**SAUSALITO-MARIN CITY SANITARY DISTRICT**  
**SOUTH PRIMARY CLARIFIER REHABILITATION PROJECT**

**Addendum No. 2**

<b>CHLORINE CONTACT STRUCTURE</b>	Scale 1/4" = 1'-0"
<b>PLAN AND SECTIONS</b>	Job No. 0112
	Sheet <b>M-10</b>

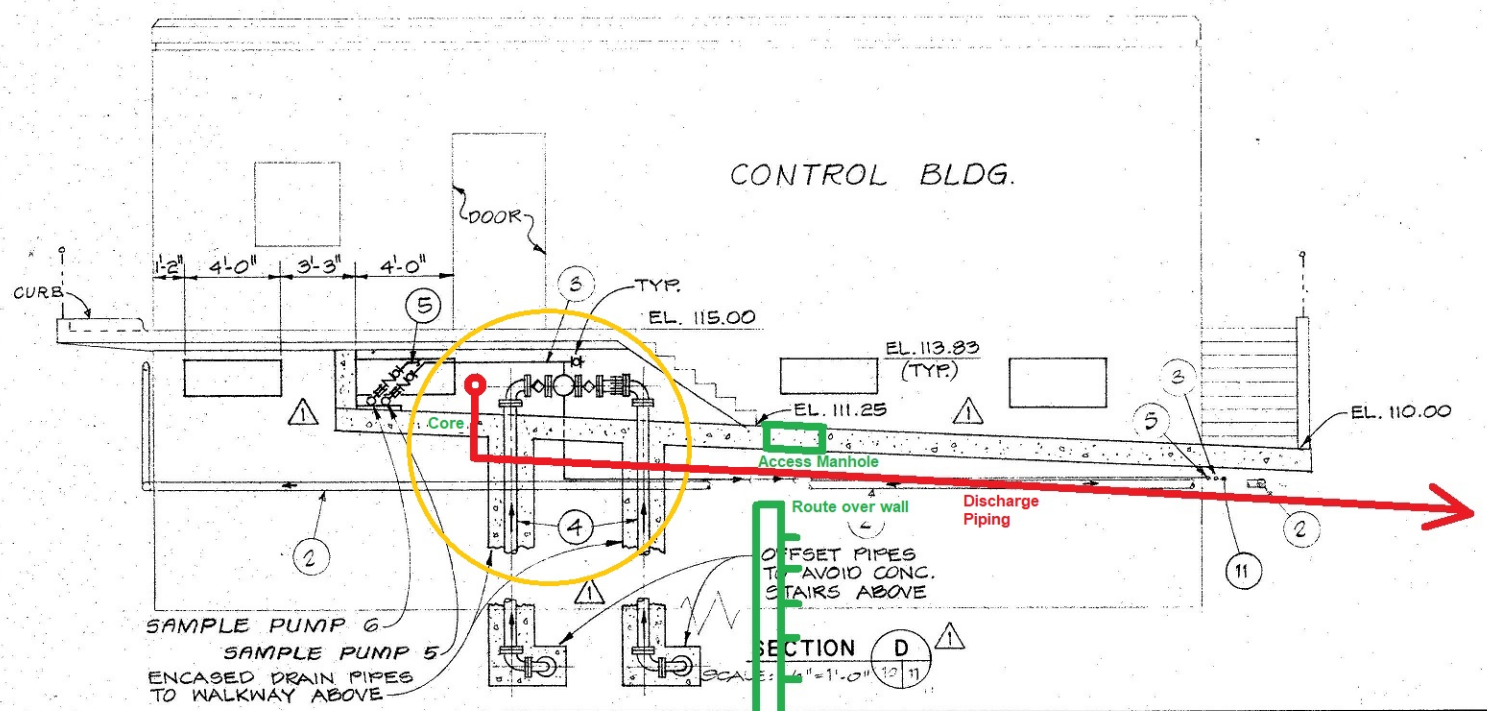
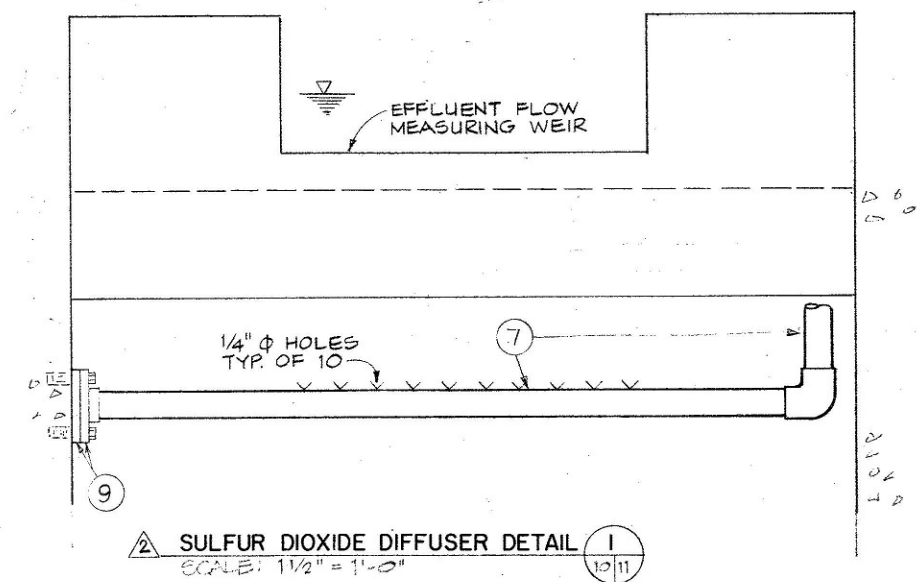
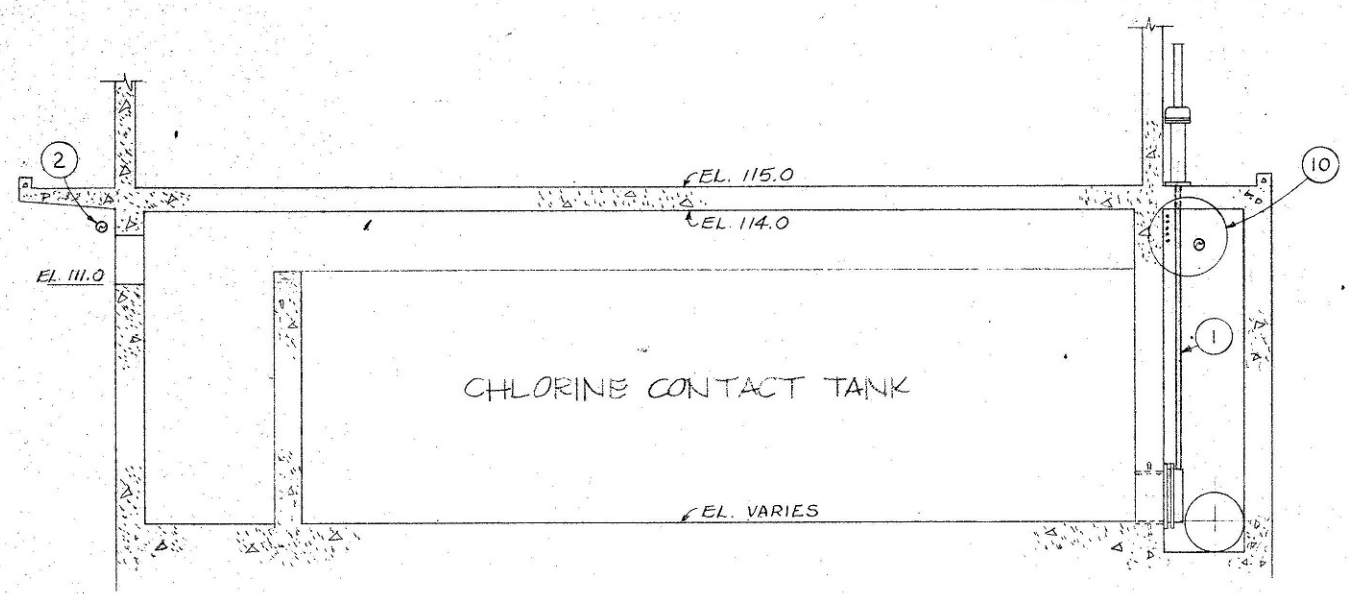
1. Contractor shall perform the following work as described to install piping for the chlorine contact tanks:
  - A. Adjust existing suction piping elbows to face each other and install valves and piping as shown on reference drawing M-10. ("Chlorine Contact Structure Plan and Sections") Piping includes 2 – 6" plug valves, 1 FCA, 1 - 6" Tee and piping spools as needed to connect both lines. One of the existing flange-to-camlock spools is to be mounted on the Tee, and the second is to be returned to Owner.

- B. Suction piping (outlined in A. above) shall be 6" coated ductile iron as detailed in project specifications.
  - C. Discharge piping is to be installed near suction piping and routed through the causeway using a core drill. Piping shall be installed in the core using a link seal for 4" piping. The link seal shall be grouted on top, flush with surface.

Access point via MH

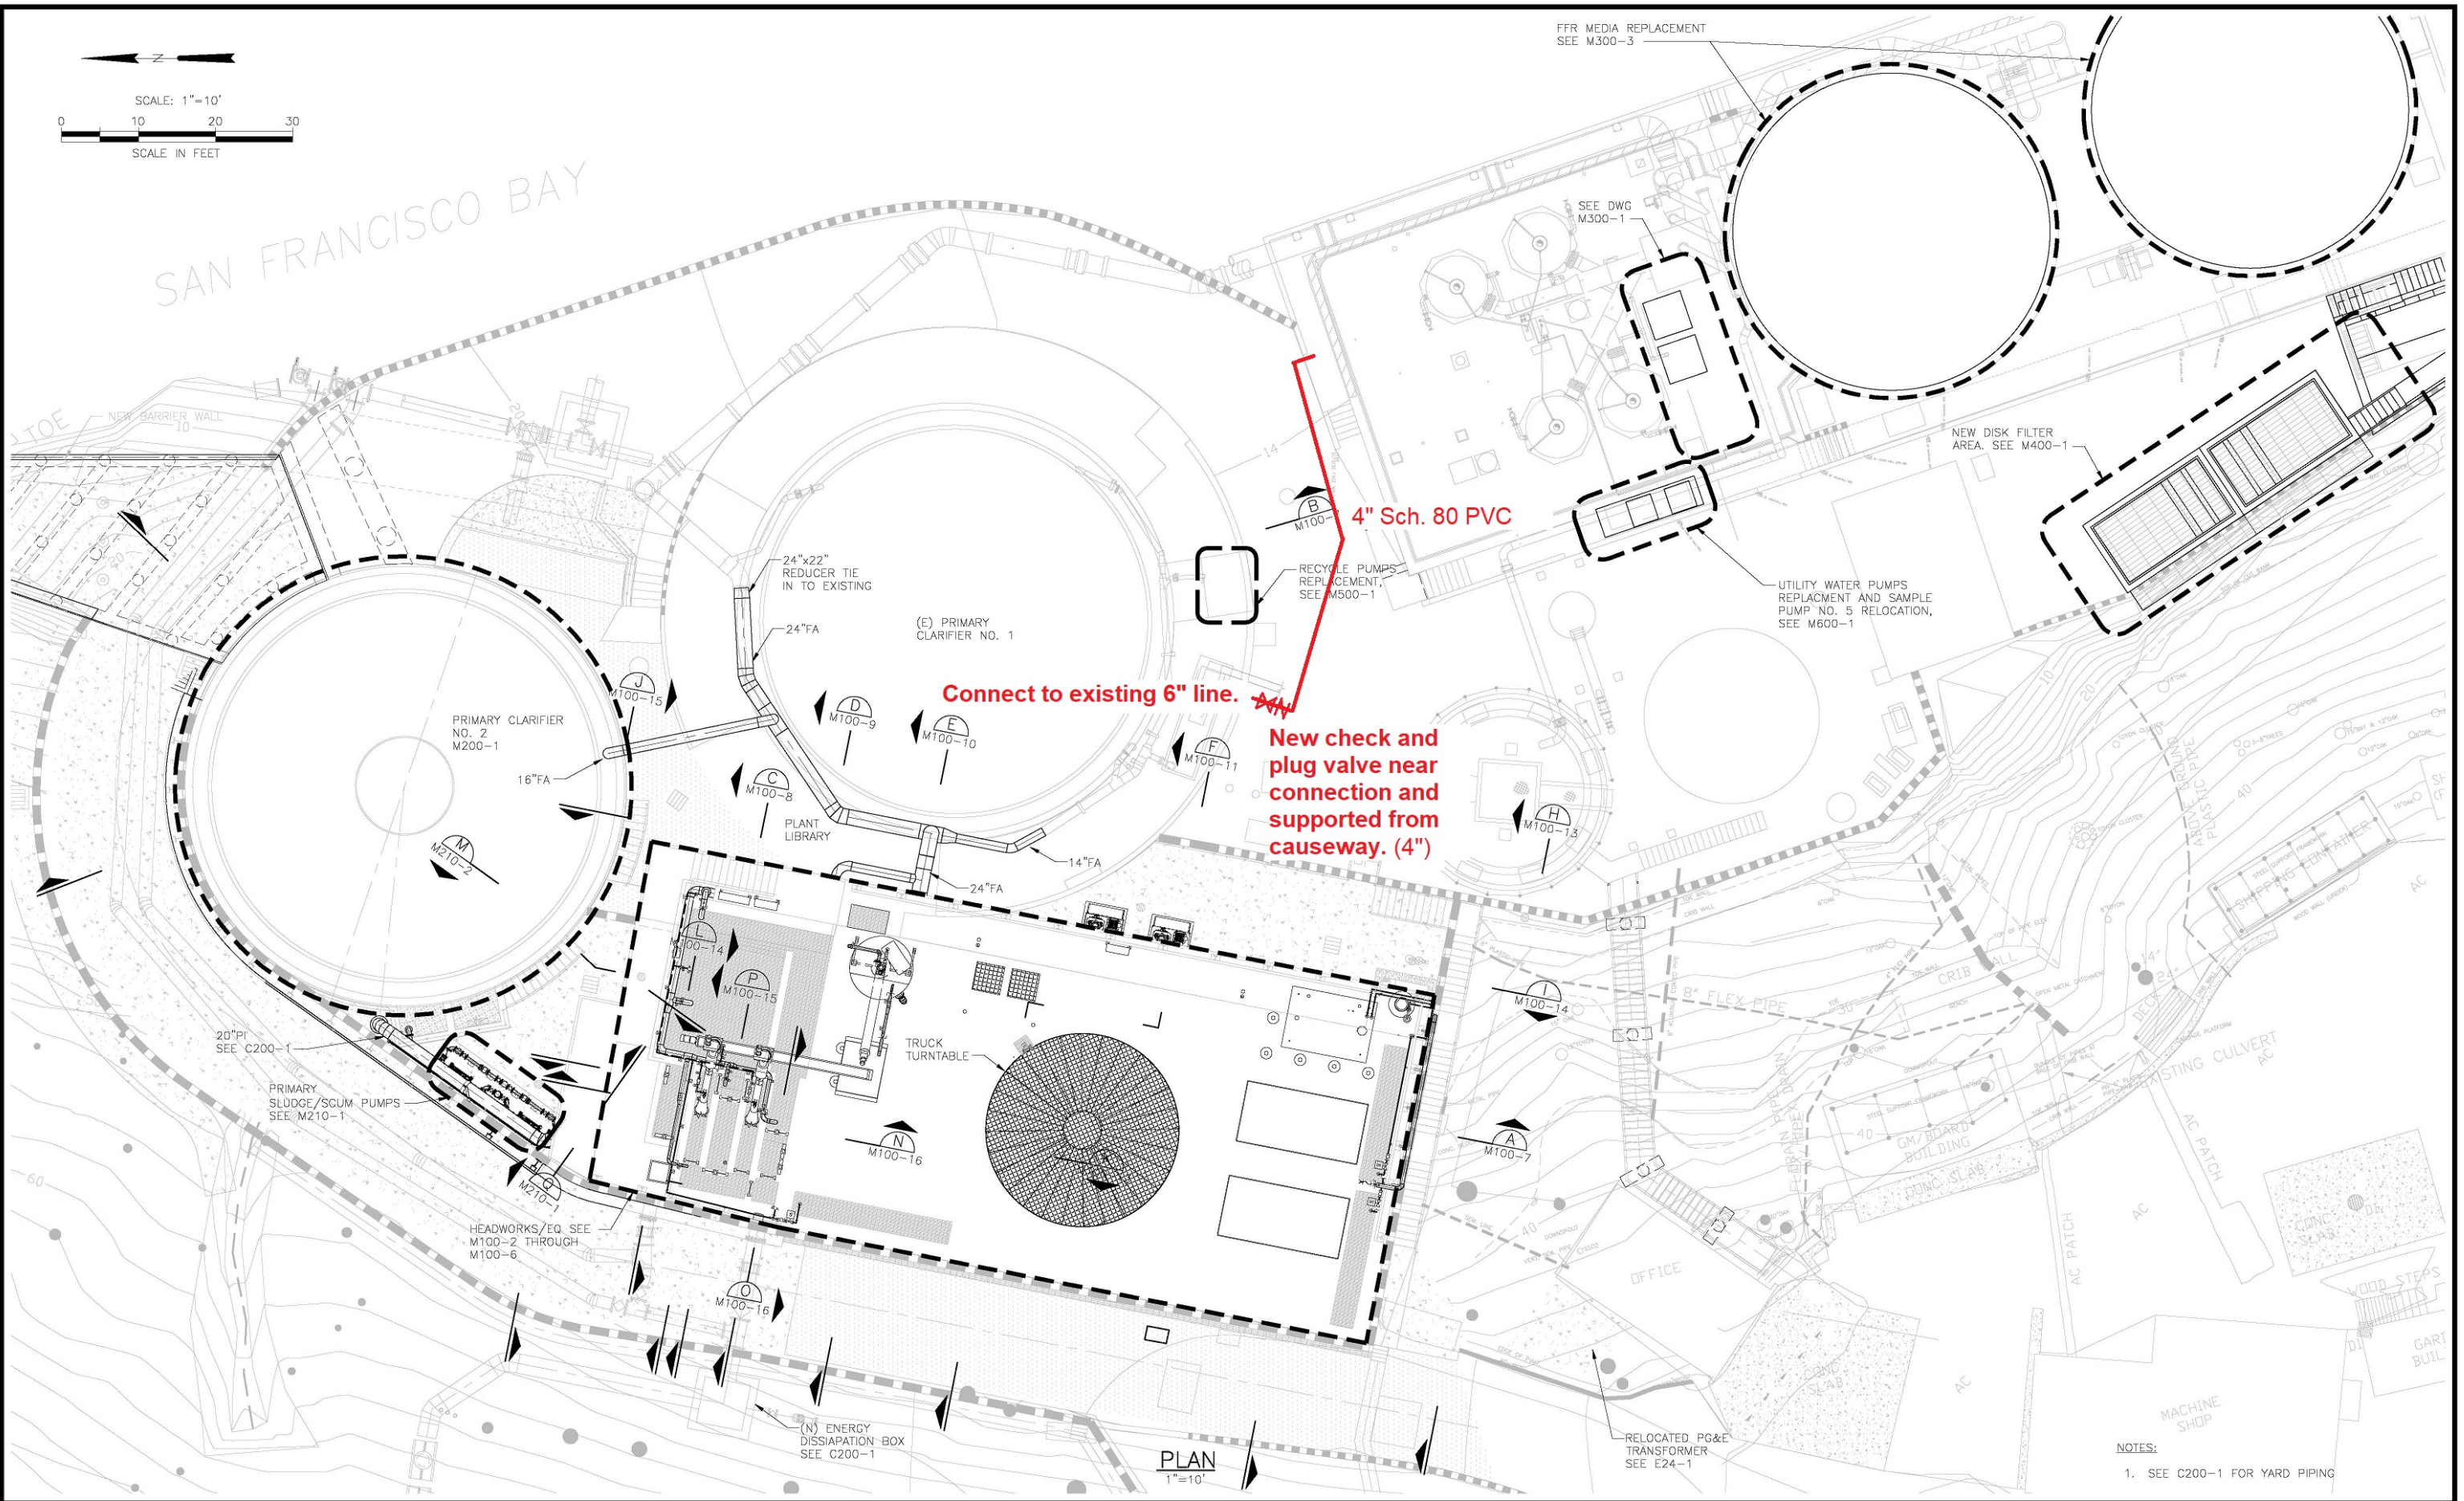
- D. Discharge piping shall be 4" Schedule 80 PVC. All piping shall be supported from the ceiling of the causeway and spaced as required by project specifications. Total distance is approximately 70'.

- E. The 4" discharge pipe shall be connected to an existing 6" Schedule 80 PVC pipe. The discharge pipe shall include a plug valve and check valve near the connection point, fully supported from the causeway.

Piping Route is crowded.

Connection Point  
for 4" Discharge  
Piping.

# SUMP PUMPS

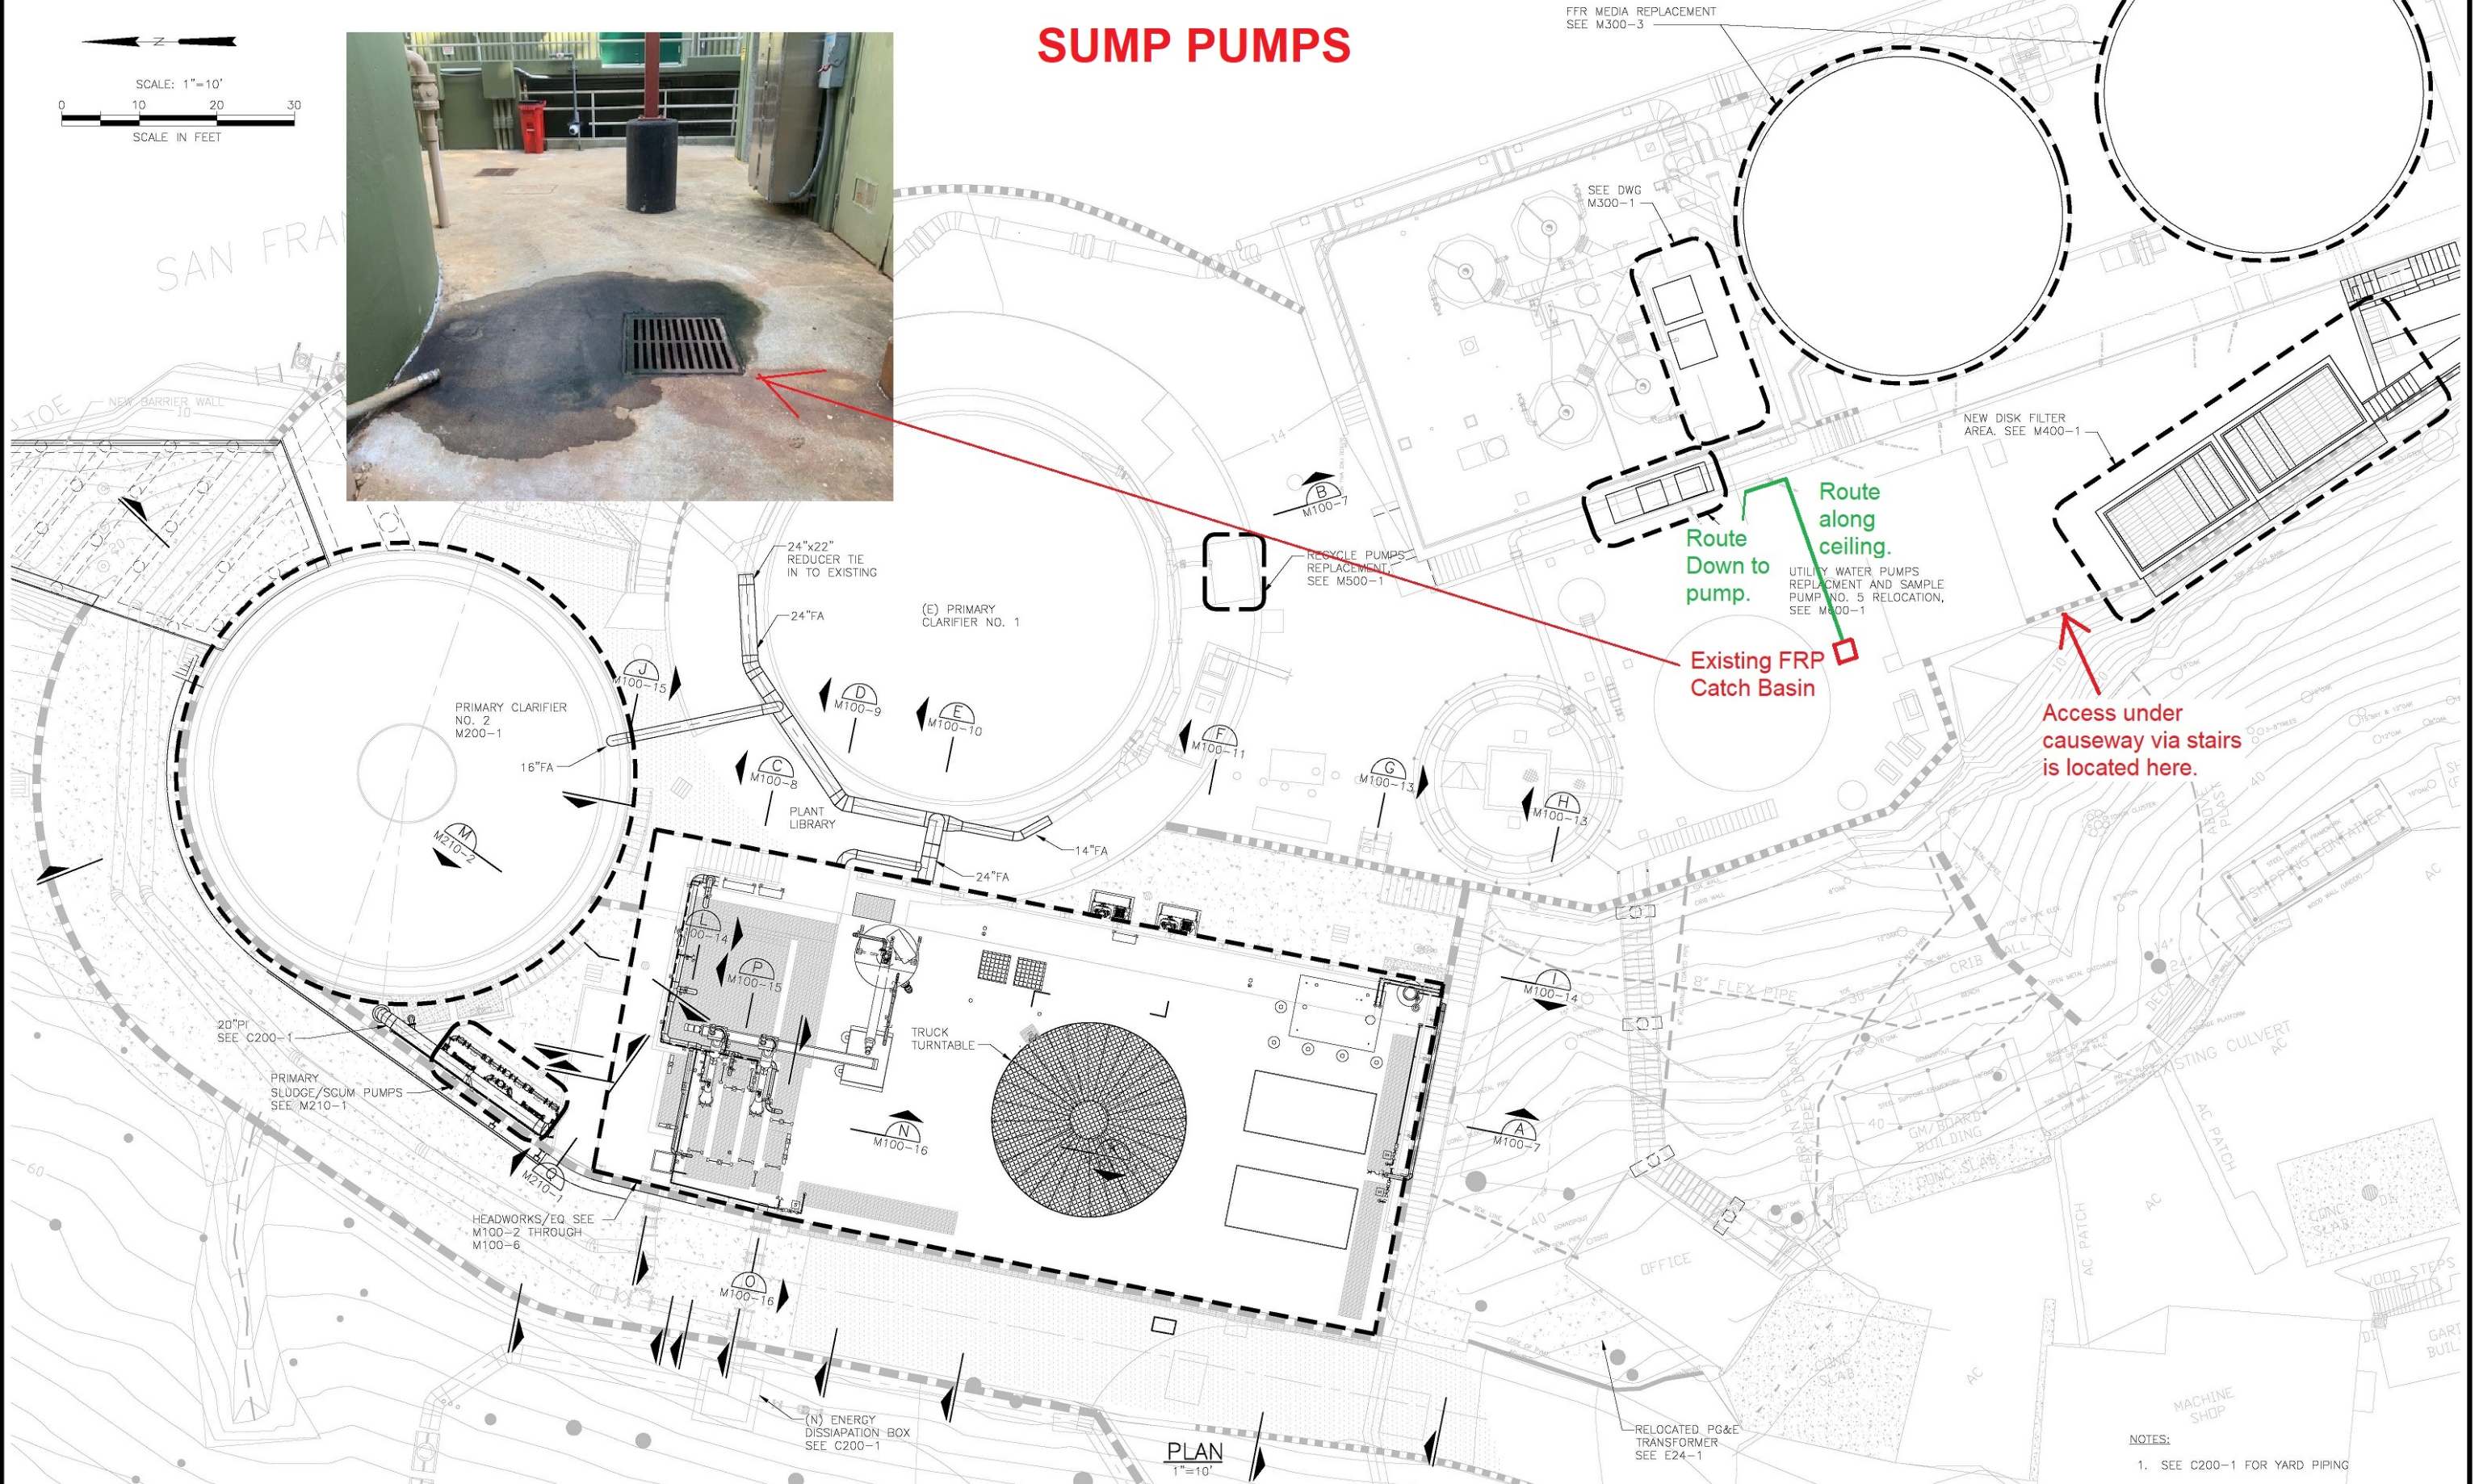
2. Contractor shall perform the following work as described to install sump pump piping:
  - A. Install 2" Schedule 80 PVC piping and pipe supports under causeway as required to tie existing sump pumps (2) to existing storm drain catch basin. Each pump shall be routed separately to the catch basin. The total length of piping is approximately 50' for each pump.
  - B. Piping shall attach to a 2" NPT fitting on each of pump.
  - C. 2" true-union Schedule 80 PVC ball check valves shall be installed on the vertical section of each pipe run.
  - D. Schedule 80 PVC bulkhead fittings shall be installed on an existing FRP catch basin.
